SUPPLEMENTAL SUBMISSION AND RESPONSE TO COMMENTS

To: Town of North Castle Planning Board
From: Airport Campus and Toll Brothers
Date: November 13, 2023
Re: Subdivision, Site Plan, Wetland Permit, and Tree Removal Permit Redevelopment of the Former MBIA Headquarters Site

Enclosed for filing with the Planning Board in response to the Town of North Castle Planning Department's comments, dated 10/16/2023 and the Planning Board's 10/23/23 Meeting please find revised and additional drawings along with substantive responses prepared by the entire project team.

FIG-SITE.dwg; NET LOT.tob NET LOT AREA.IS

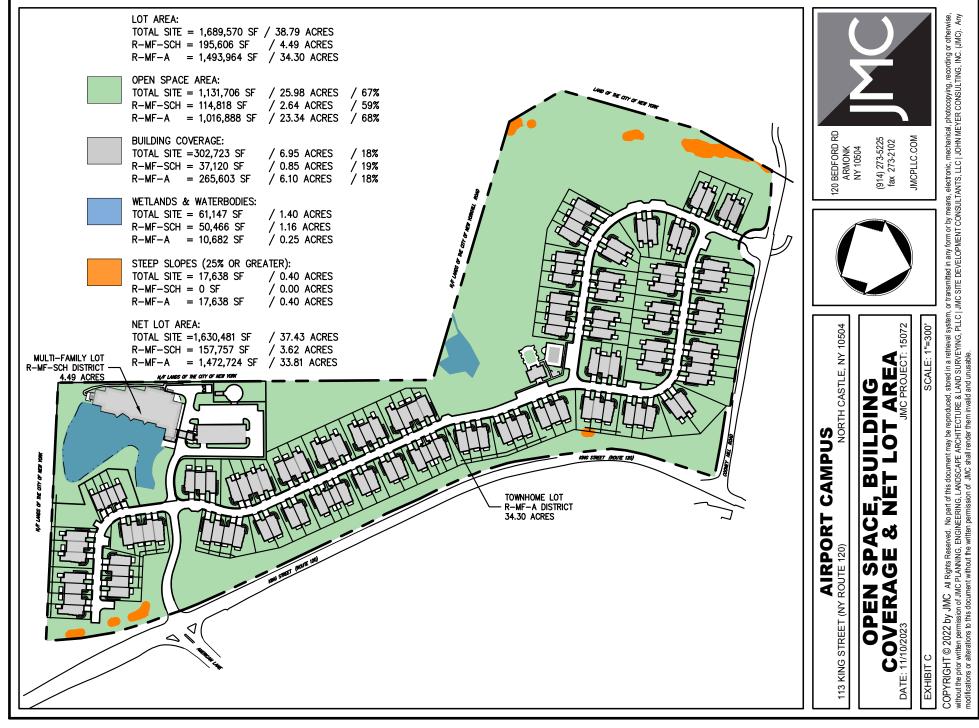
Pursuant to Section 355-24.F of the Town Code, the site plan should be revised to depict and quantify the proposed amount of open space and recreation area. At least 50% of the gross area of the site is required to be open space or recreation area.

Density in the R-MF-SCH and R-MF-A zones are based upon Net Lot Area. The Zoning Compliance Chart shall be revised to depict net lot area, the calculations used to derive net lot area as well as an exhibit demonstrating the areas used to calculate net lot area.

Comment No. 11

The Applicant should submit a building coverage exhibit for the R-MF-A and R-MF-SCH zoning districts.

Please see the attached Exhibit C "Open Space, Building Coverage & Net Lot Area" which provides calculations of open space, building coverage, and net lot area. This exhibit demonstrates that the amount of open space for the total site is 67%, which is greater than the 50% requirement.

Drawing C-000 "Cover Sheet" has been updated to include "net lot area" on the Zoning Compliance Table and net lot area calculations below the Area Map. Exhibit C "Open Space, Building Coverage & Net Lot Area" has been prepared to show the areas used to calculate net lot area.

Please see the attached Exhibit C "Open Space, Building Coverage & Net Lot Area" which illustrates open space, building coverage, and net lot area. The calculations include R-MF-SCH and R-MF-A District breakdowns.
